Ferry Services in Scotland

Submission from Euan Haig

December 2024

LNG and Boil-Off Gas (BOG)

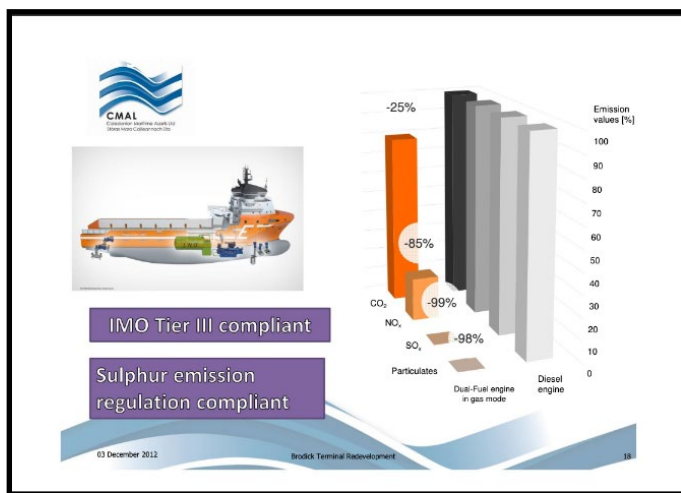
TS, CalMac, and CMAL have a long history of omitting or understating emissions. CMAL showed this slide in its presentation (Ref 8) to Arran ferry users on 3rd December 2012. It omitted mention of 'methane slip', BOG, and emissions from transport. Incompleteness renders it invalid.
